In re application of: Patrick K. Egan et al. : Date: June 8, 2000
Group Art Unit: 2831 : IBM Corporation
Examiner: K. Cuneo : Intellectual Property Law
Serial No.: 09/074,213 : Dept. 917, Bldg. 006-1
Filed: May 7, 1998 : 3605 Highway 52 North
Title: BACKPLANE POWER : Rochester, MN 55901
DISTRIBUTION SYSTEM

PROPOSED AMENDMENT TO THE DRAWING

FIGURE 2

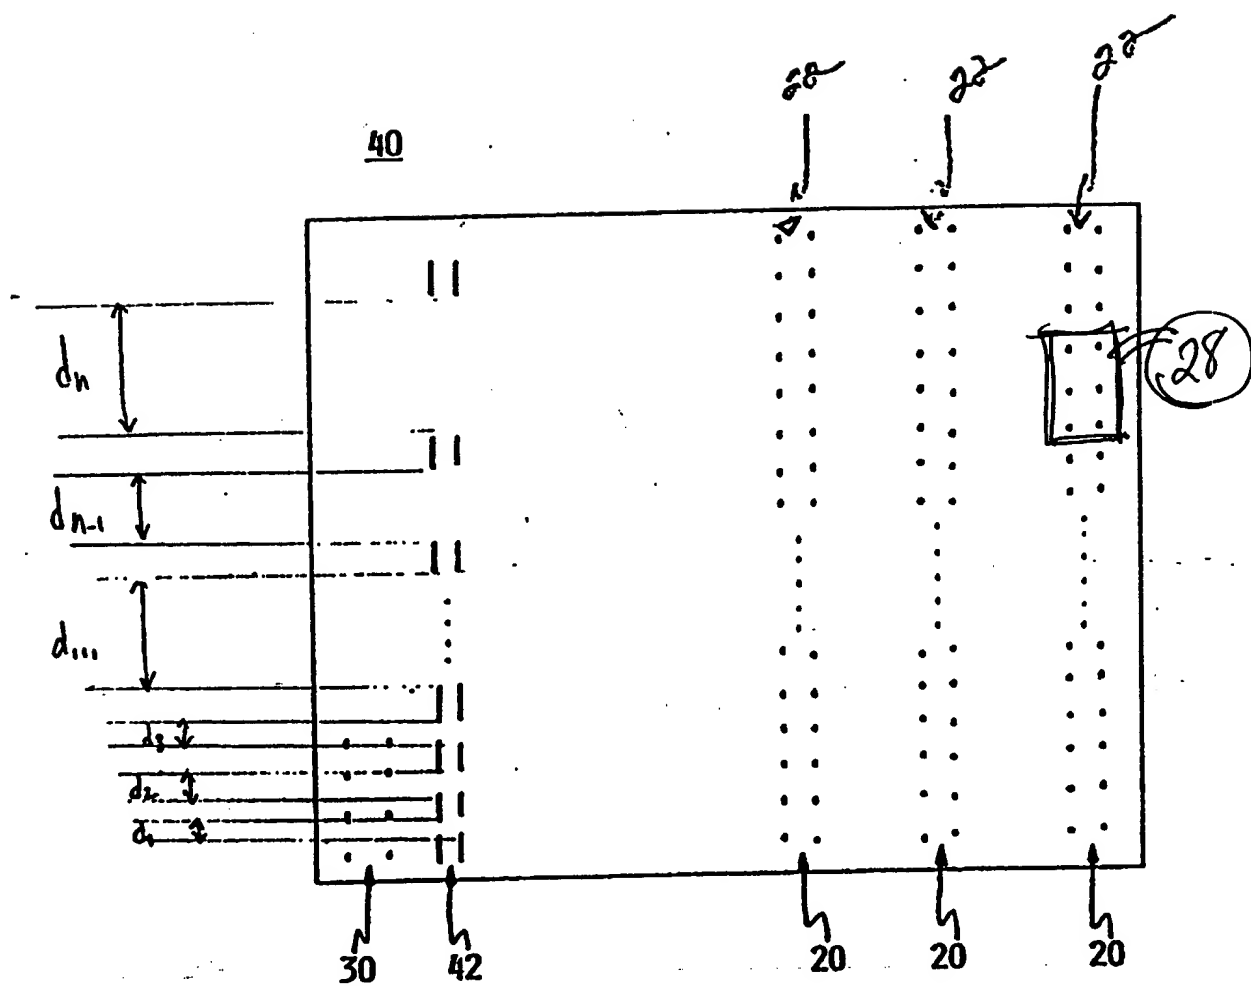
Please insert a rectangular block with a lead line to a reference numeral 28, as shown.

a rectangular block, a pointer, and a reference numeral 28 has been added representing connector straps or pads, wiring networks, etc. as described in the specification at page 4, lines 23-24 and in claim 11.

Figure 3

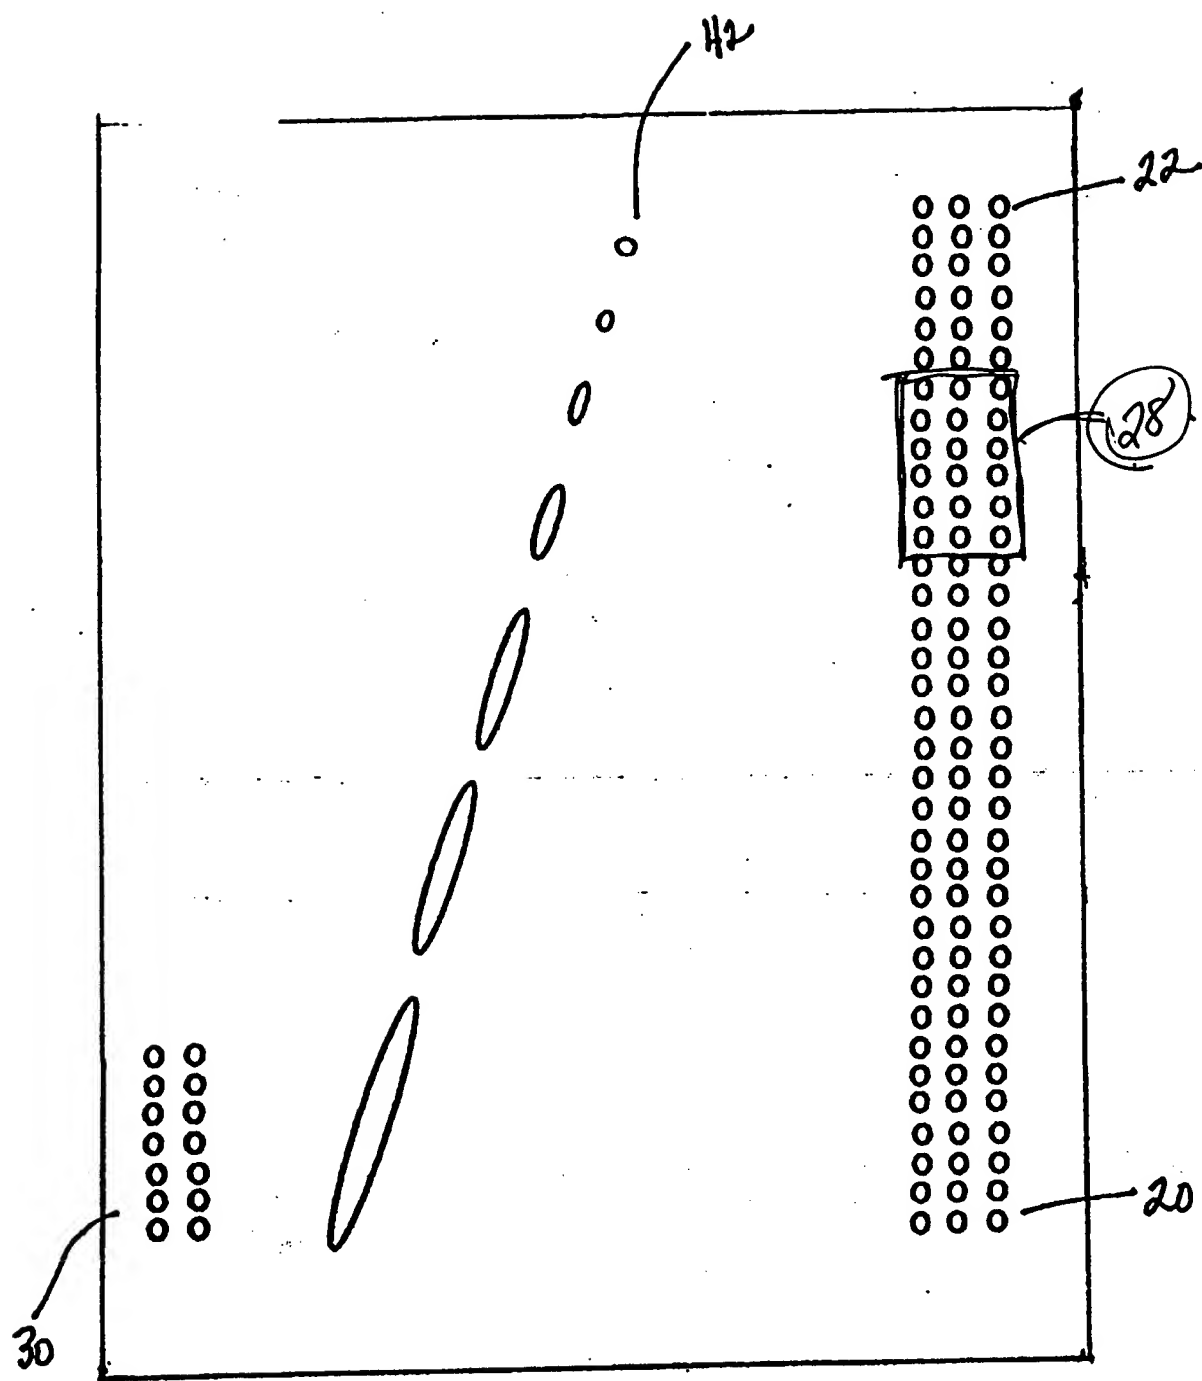
Please insert a rectangular block with a lead line to a reference numeral 28, as shown.

a rectangular block, a pointer, and a reference numeral 28 has been added representing connector straps or pads, wiring networks, etc. as described in the specification at page 4, lines 23-24 and in claim 11.

Figure 4
Sheet 3 of 4
Egan et al.
R0905-122B

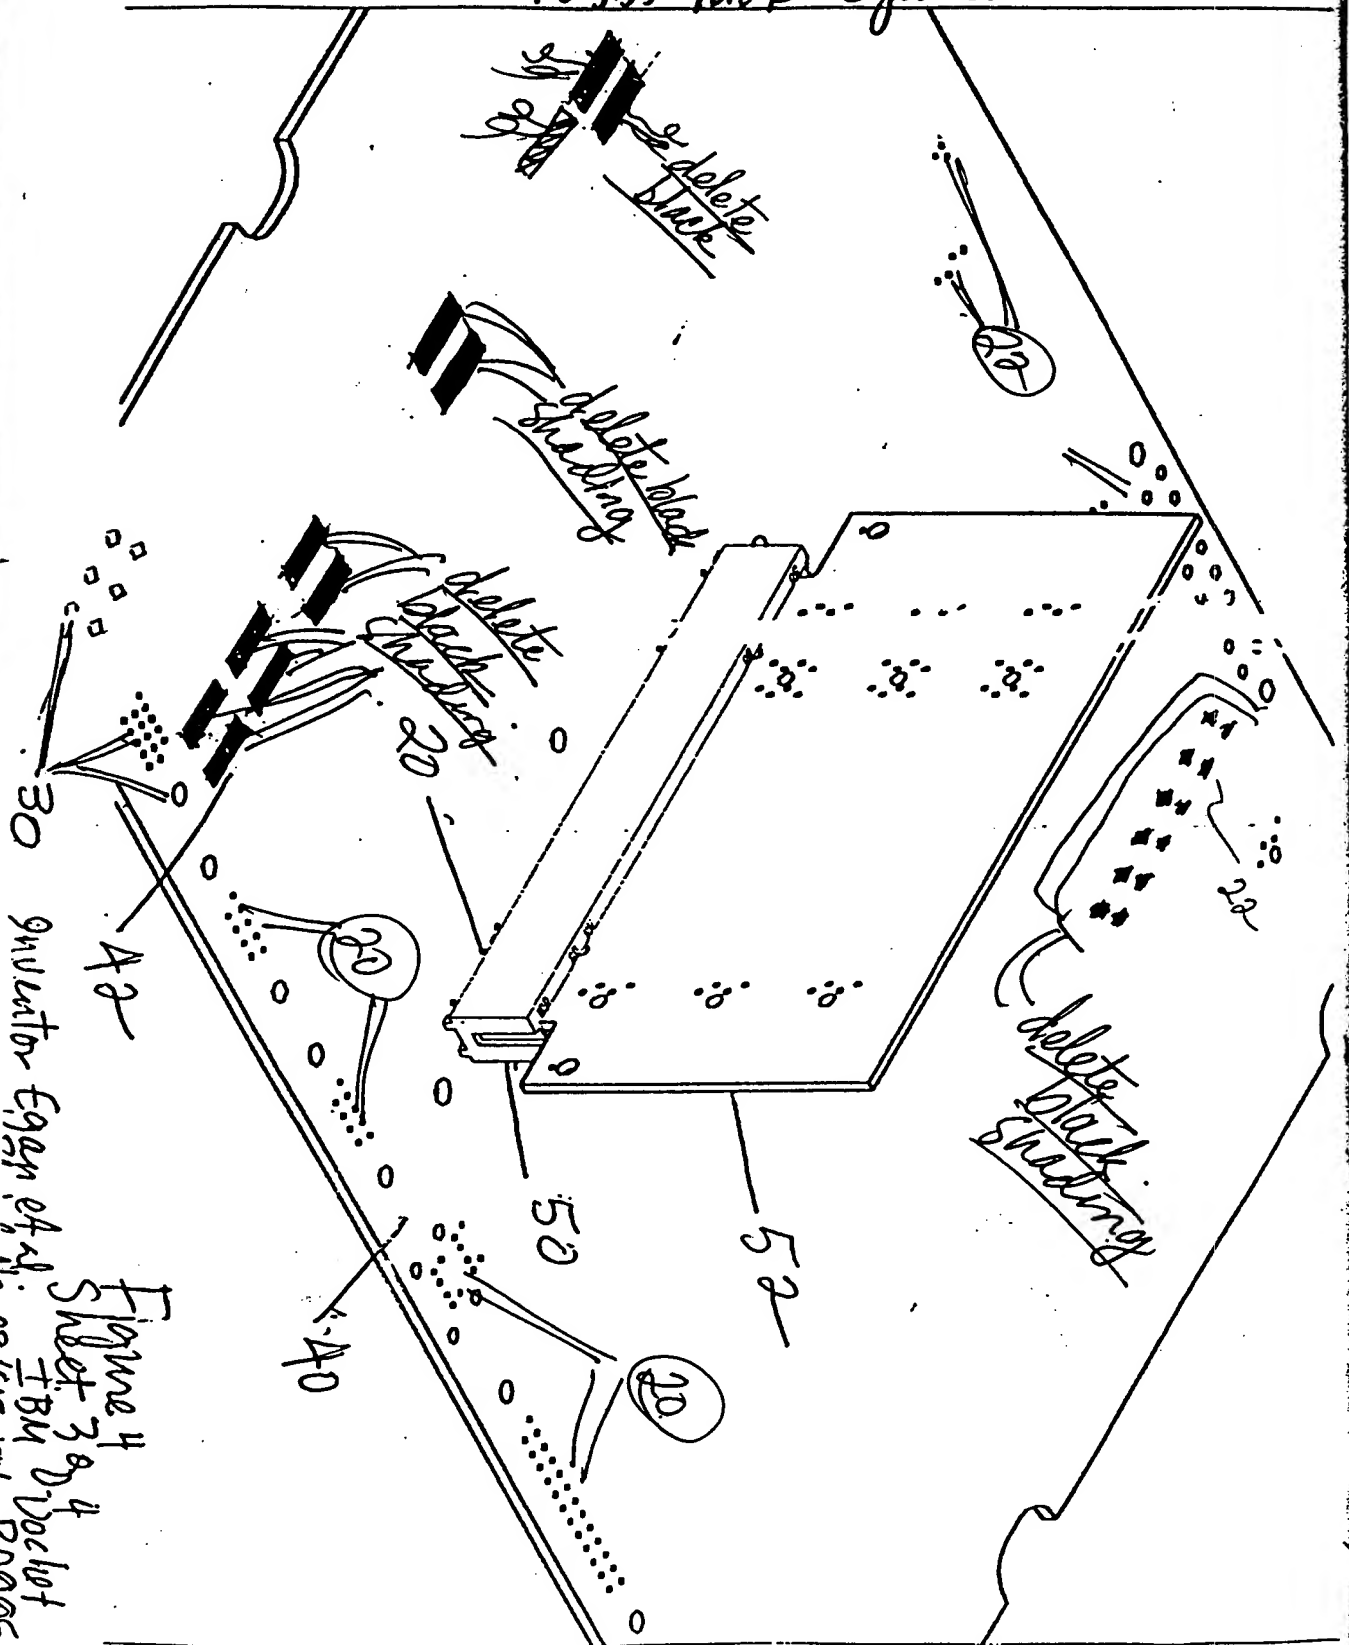
Please insert and extend the edges of the powerplane 40 so the lower right-hand portion of the figure is not cut off.

Please delete the black shading from the impedance variations 42 at the left third of the page and at the far load locations 22 towards the top of the page, without disclaimer or prejudice.

Please insert lead lines from the reference numeral 20 to the holes on powerplane as indicated.

Please insert lead lines from the reference numeral 22 to the holes on powerplane as indicated.

Please insert lead lines from the reference numeral 30 to the holes on powerplane as indicated.

the edges of the powerplane 40 have been inserted and extended so that the lower right-hand portion of the figure is not cut off;

the coloring of the impedance variations and load locations of Figure 4 has been deleted. In doing so, however, Applicants maintain that the impedance variations 42 are not limited to the geometric openings presented but can be openings of different shapes and/or material of different resistivity than that of powerplane 40;

pointer lines have been inserted from reference numerals 20, 22, and 30 to the different holes on the powerplane;

the Examiner states that it is unclear what the shapes of 20 and 22 are. Respectfully, the specification states that the source locations (30) and load locations (20 and 22) be capable of receiving pins. The shape of the pins is not disclosed in the specification and it is known in the art that connector pins come in all kinds of shapes; circular, oval, octagonal, flat, etc. Applicants respectfully decline to limit the invention to a particular rendition and maintain that the source locations and the load locations are the same part as referenced in Figures 2, 3, and 4.
